Access Compliance Report

Public Rights-of-Way

(Curb Ramps)

Intersection ID: 51663	Main Street: CORSICA_FOREST_DR	Cross Street: TOSCANA_WY	Location: S
ADA ID: 8305201DAC0C	Ramp Type: BlendTrans1	Initial Pass/Fail: Pass	Overall Compliance: No
Severity Score: 2.75			
Codes/Mitigation Info/Possible Solution		Field Measurements/Component Compliance

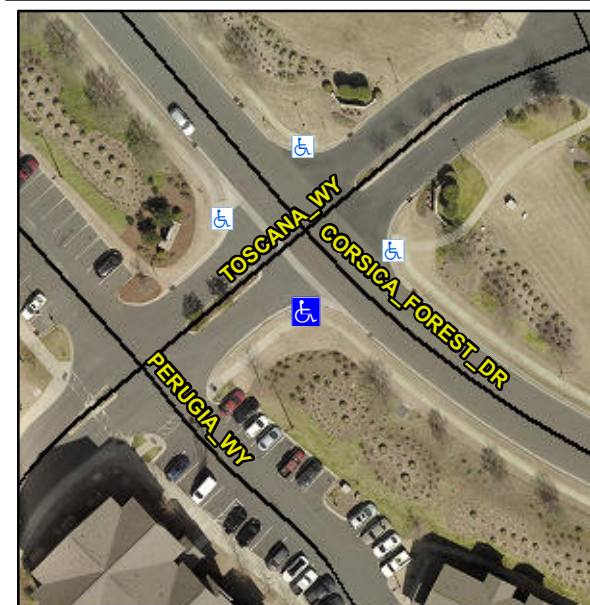
R304.5.3, R304.2.1, R305.1.4, R305.2

Compliance	Description	Data	Compliance	Description	Data
N/A	Ramp Length (in)	48.0	Yes	BlendTrans Slope (%)	3.3
Yes	Ramp Width (in)	54.0	No	BlendTrans XSlope (%)	2.3
N/A	Flare Type LT	Sloped	N/A	Flare Type RT	Sloped
N/A	Flare Slope LT (%)	4.1	N/A	Flare Slope RT (%)	3.2
N/A	Flare Traversable LT?	No	N/A	Flare Traversable RT?	No
Yes	Landing Length (in)	58.0	Yes	DWS Provided?	Yes
No	Landing Width (in)	47.0	Yes	DWS Contrast?	Yes
Yes	Landing Slope (%)	0.8	Yes	DWS Length (in)	24.0
No	Landing X Slope (%)	2.2	No	DWS Full Width?	No
N/A	Landing Curb? (Y/N)	No	No	DWS Offset (in)	2.5
N/A	Shared Landing?	No			
Yes	Gutter Ponding?	No	Yes	Gutter Slope (%)	1.9
Yes	Gutter Lip Ht (in)	0.0	Yes	Gutter X Slope (%)	1.4
N/A	Painted X Walk1?	No	N/A	Painted X Walk2?	No
	X Walk 1 Direction	To NE		X Walk 2 Direction	To NW
	X Walk 1 Width (in)	N/A		X Walk 2 Width (in)	N/A
	X Walk 1 Slope (%)	7.2		X Walk 2 Slope (%)	7.2
	X Walk 1 X Slope (%)	3.2		X Walk 2 X Slope (%)	3.5

Remove & Replace Curb Ramp With Two New Directional Ramps or Equivalent.
